SUBJECT: Response to Comments for the Updated Remedial Action Plan at the Former Clusters Storage Yard (Proposed Hillcrest Project), 511 Ohlone Parkway, Watsonville, California

RESPONSIVENESS SUMMARY - UPDATED REMEDIAL ACTION PLAN, DATED JANUARY 12, 2021

Response to Public Comments
Updated Remedial Action Plan
511 Ohlone Parkway, Watsonville

Sheet # C5.1: *Remediation Pit Grading Plan*
and
Sheet C5.2: *Site Environmental Grading Plan*

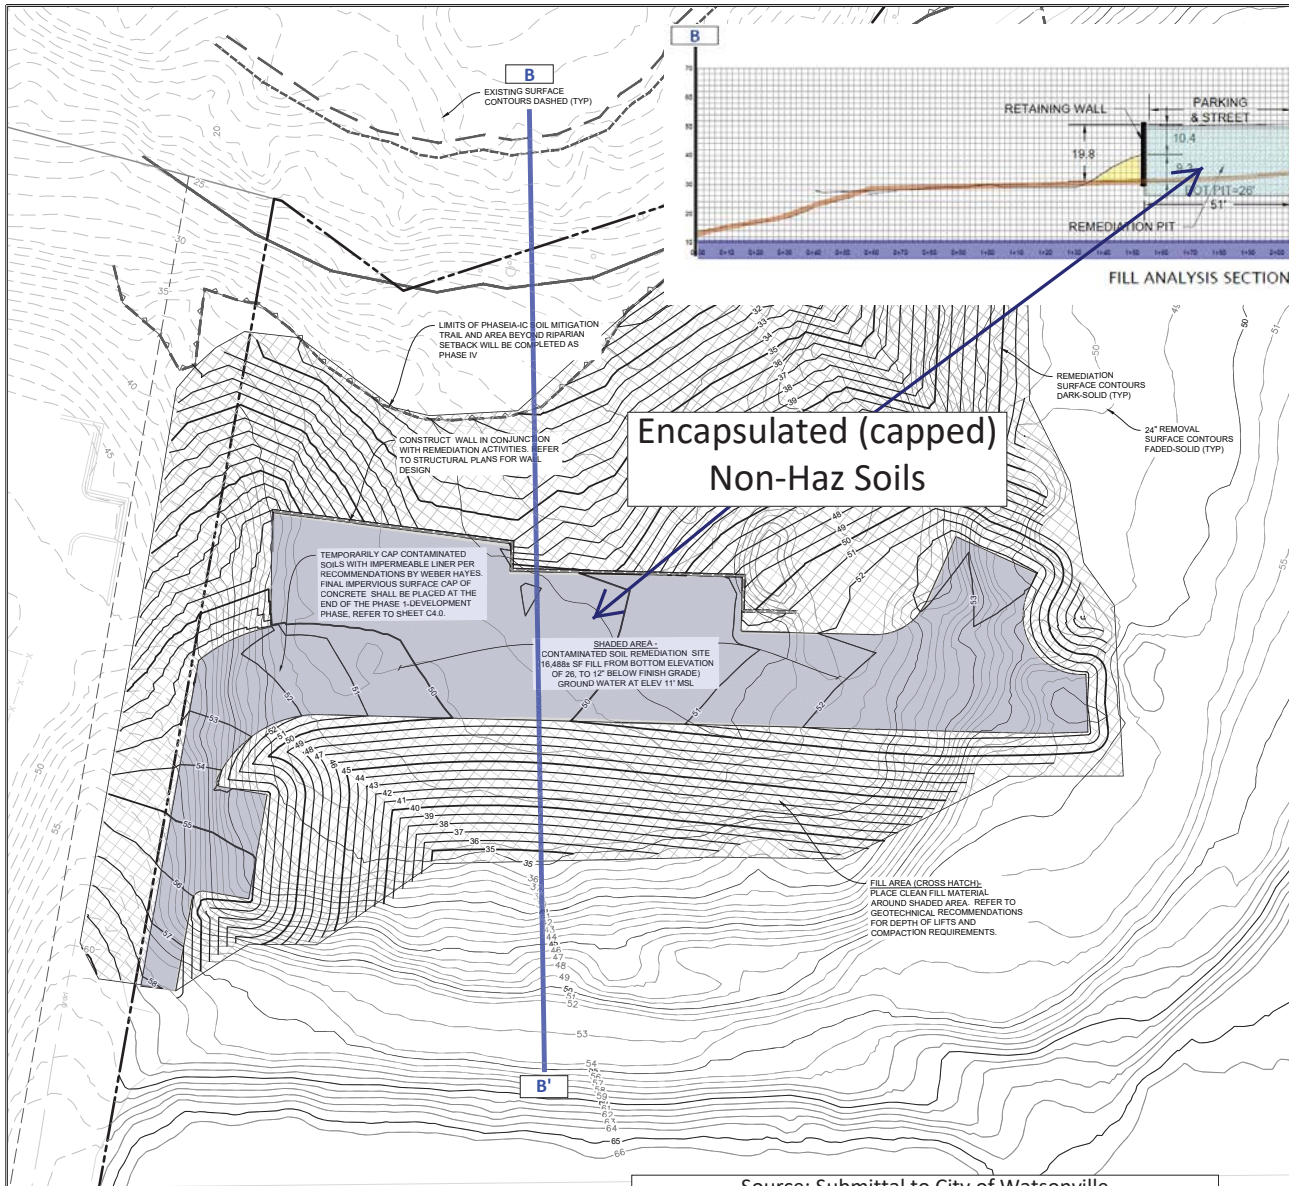
Wat-4	The project's 06/04/2021 REMEDIATION PIT GRADING PLAN, Sht. C5.1, refers to "STRUCTURAL PLANS FOR WALL DESIGN" and to "PLACE GEO-GRID REINFORCEMENT MATERIAL AS DIRECTED BY THE STRUCTURAL PLANS", but we are not aware of the existence of any structural plans. It also calls for a "FINAL IMPERVIOUS SURFACE CAP OF CONCRETE OR ASPHALT" but doesn't specify the material or its thickness.	This is a geotechnical-related comment that has been addressed by the Hillcrest engineering team for the City of Watsonville plan check and grading review/approval process.

4. The project's 06/04/2021 REMEDIATION PIT GRADING PLAN, Sht. C5.1, refers to "STRUCTURAL PLANS FOR WALL DESIGN" and to "PLACE GEO-GRID REINFORCEMENT MATERIAL AS DIRECTED BY THE STRUCTURAL PLANS", but we are not aware of the existence of any structural plans. It also calls for a "FINAL IMPERVIOUS SURFACE CAP OF CONCRETE OR ASPHALT" but doesn't specify the material or its thickness.

- THE REMEDIATION PIT WILL BE CONSTRUCTED BACKFILLING WITH CONTAMINATED SOILS IN INCREMENTS WHILE SIMULTANEOUSLY CONSTRUCTING THE BLOCK WALL ALONG THE NORTH SIDE OF THE REMEDIATION PIT. PLACE GEO-GRID REINFORCEMENT MATERIAL AS DIRECTED BY THE STRUCTURAL PLANS. BACKFILLING ASSUMES A 15% COMPACTION FACTOR AT 12 IN LIFTS COMPACTED AT 90% MIN. RELATIVE COMPACTION, OR AS DIRECTED OTHERWISE BY THE GEOTECHNICAL ENGINEER.

Source: Submittal to City of Watsonville
Civil Sheet C5.1: Remediation Pit Grading Plan & Cut and Fill Analysis
 Revised August 5, 2021, Ramsey Civil Engineering and annotated by Weber, Hayes & Associates (note the cross-section presents finished grade)
